### **ADDENDUM NO. 1**

Date: 7/11/2017

**Project: Field Improvements at West Campus High School**

**West Campus High School**  
Synthetic Practice Field & Road Improvements, Inc. 1

Title: DEMOLITION PLAN		Ref: C1.1.1	
Project: SCUSD WEST CAMPUS HIGH SCHOOL SCIENCE & TECHNOLOGY BUILDING INCREMENT 1		Job No: WCE No.16-171	Sheet No. <b>AD1-1</b>
		Scale: 1" = 20'-0"	
		Date: 7-11-2017

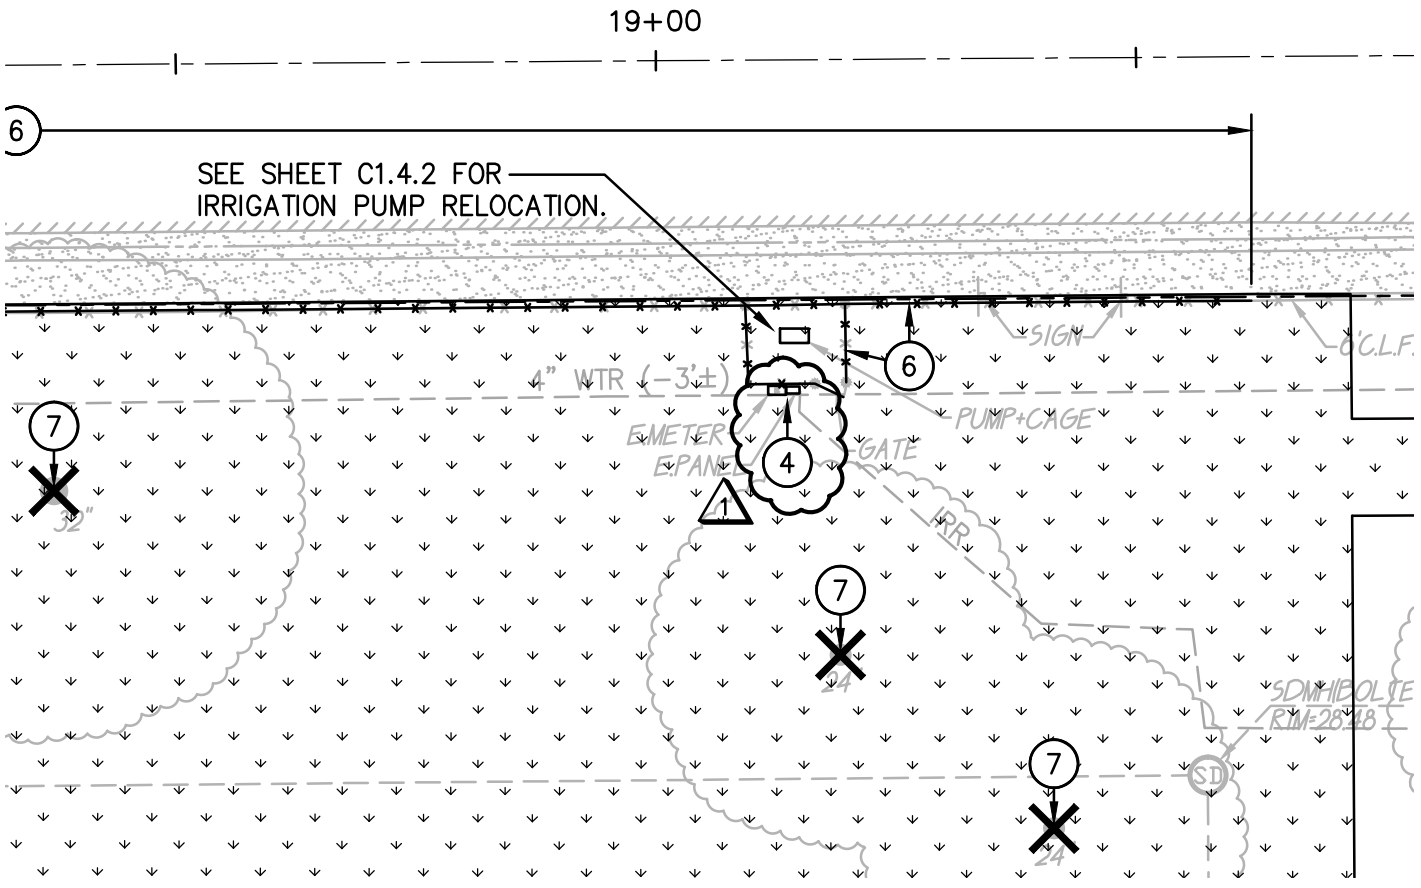
1. AD1-1 DEMOLITION PLAN
  - a. Note updated for SMUD meter to be relocated as well.
2. AD1-2 DEMOLITION PLAN
  - a. Backstops added to demolition.
3. AD1-3 GRADING PLAN
  - a. Existing light pole to be re-installed, location clarified.
4. AD1-4 POLE BASE DETAIL
  - a. Detail provided.
5. AD1-5 SITE DOMESTIC WATER AND FIELD IRRIGATION PLAN
  - a. Irrigation note added for clarification.
6. AD1-6 PAVING PLAN
  - a. Paving type added, paving type updated.

**1** 4. REMOVE AND RELOCATE EXISTING SMUD SERVICE FOR IRRIGATION PUMP SYSTEM. CONTRACTOR TO PROVIDE ALL TRENCHING, CONDUIT AND WIRE AS NEEDED. CONTRACTOR TO PROVIDE SMUD APPLICATION AND ALL FEES FOR SMUD TO RELOCATE SERVICE TO NEW PUMP LOCATION. SEE SHEET C1.4.2.

9. REMOVE EXISTING LIGHT POLE AND CONCRETE BASE. SALVAGE LIGHT POLE FOR RE-INSTALLATION. **1**

Title: GRADING PLAN		Ref: C1.3.1	
Project: SCUSD WEST CAMPUS HIGH SCHOOL SCIENCE & TECHNOLOGY BUILDING		Job No: WCE No.16-171	Sheet No.
INCREMENT 1		Scale: 1" = 20'-0"	<b>AD1-3</b>
		Date: 7-11-2017

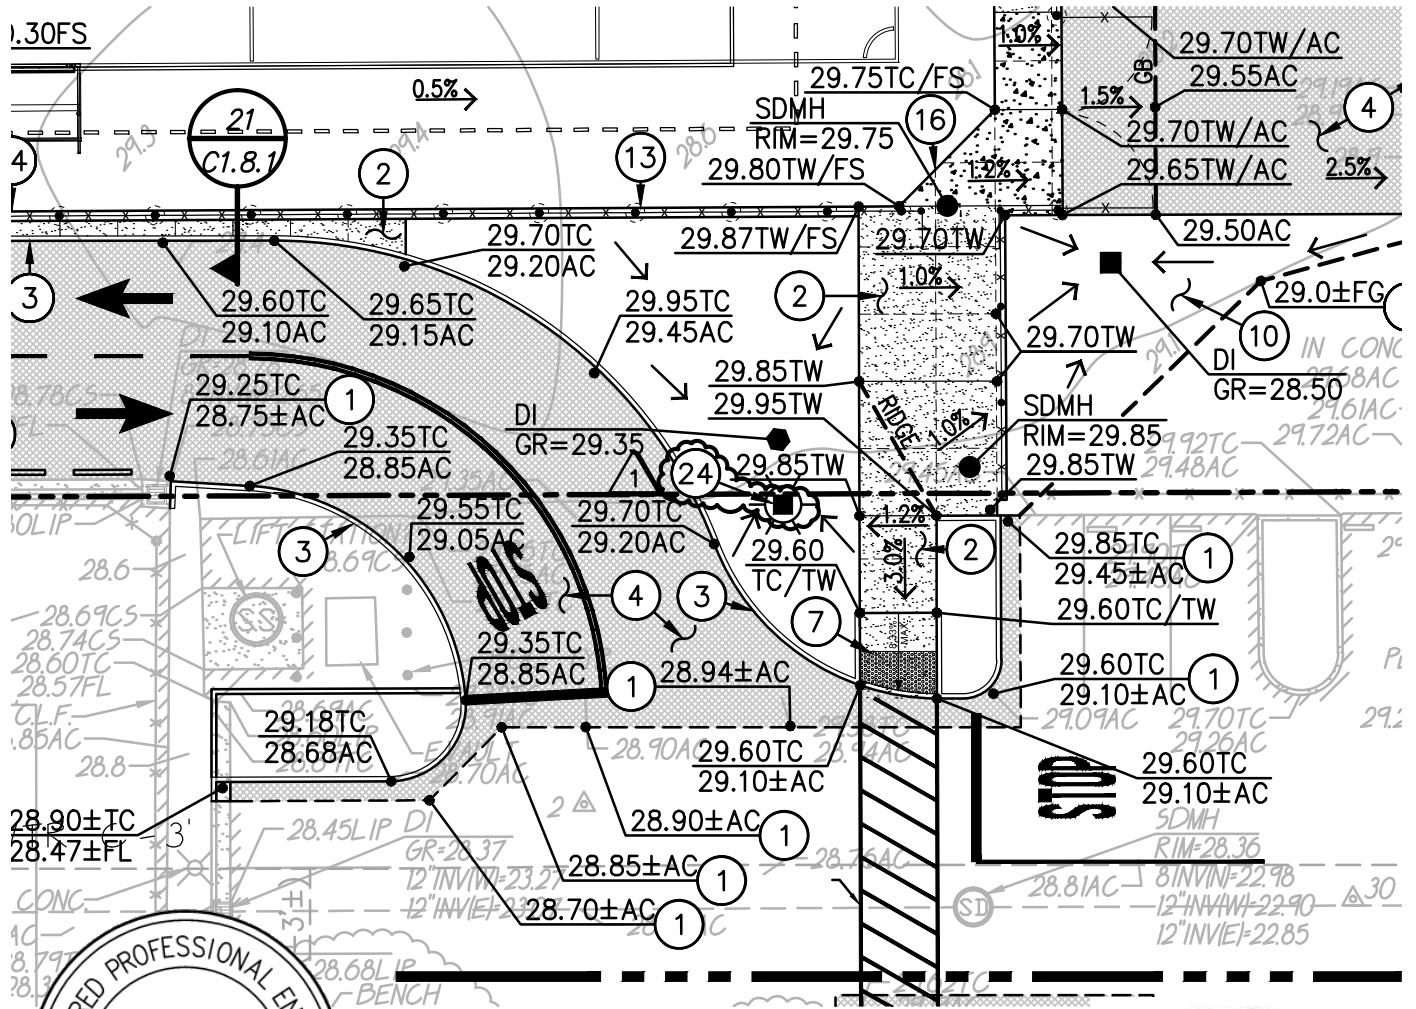
1. Identify and/or locate required temporary power on the drawings?
  - a. Refer to section 01 50 00 Temporary Facilities, 2.01 B for information about temporary power. There is no information regarding temporary power on the drawings.
2. Identify and/or locate required lighting on the drawings?
  - a. One light pole is to be relocated. See AD1-3 Grading Plan, note 24, and AD1-4 Pole Base Detail.

24. RE INSTALL LIGHT POLE ON NEW CONCRETE BASE AT LOCATION SHOWN. INCLUDE ALL NECESSARY CONDUIT AND WIRING TO RE-CONNECT TO (E) CIRCUIT.

Title: FIELD LAYOUT PLAN		Ref: C1.6.2	
Project: SCUSD WEST CAMPUS HIGH SCHOOL SCIENCE & TECHNOLOGY BUILDING INCREMENT 1		Job No: WCE No.16-171	Sheet No.
		Scale: 1" = 20'-0"	<b>AD1-7</b>
		Date: 7-11-2017

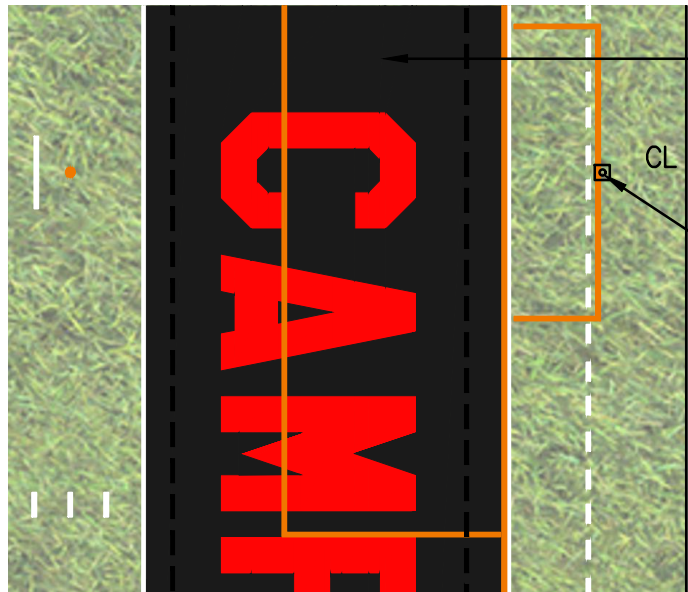
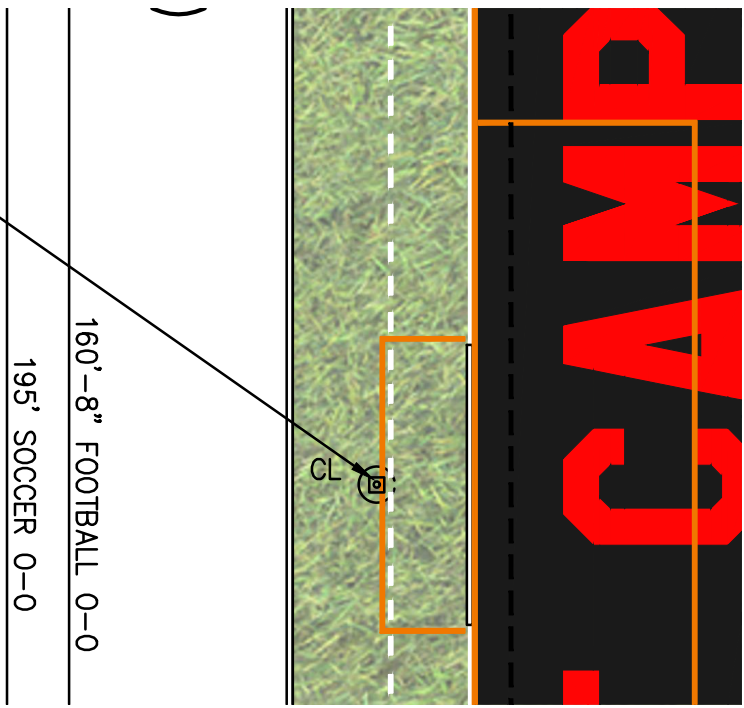
7. AD1-7 FIELD LAYOUT PLAN
  - a. Ground sleeves and soccer lock down to be installed at both goal ends.
8. AD1-8 FIELD FENCING AND EQUIPMENT PLAN
  - b. Only goal sleeves to be installed, goal posts to be provided but not installed.
9. AD1-9 FIELD FENCING SECTIONS AND DETAILS
  - c. Goal post to be provided but not installed.
10. C1.6.5 FIELD EQUIPMENT DETAILS
  - d. Some equipment not used.
11. C1.8.3 DETAILS AND SECTIONS
  - e. Field section detail updated.

1  
 PROVIDE AND INSTALL COMBINATION  
 GROUND SLEEVE AND SOCCER LOCK  
 DOWN ONLY, SEE C1.6.3.

1  
 PROVIDE AND INSTALL COMBINATION  
 GROUND SLEEVE AND SOCCER LOCK  
 DOWN ONLY, SEE C1.6.3.
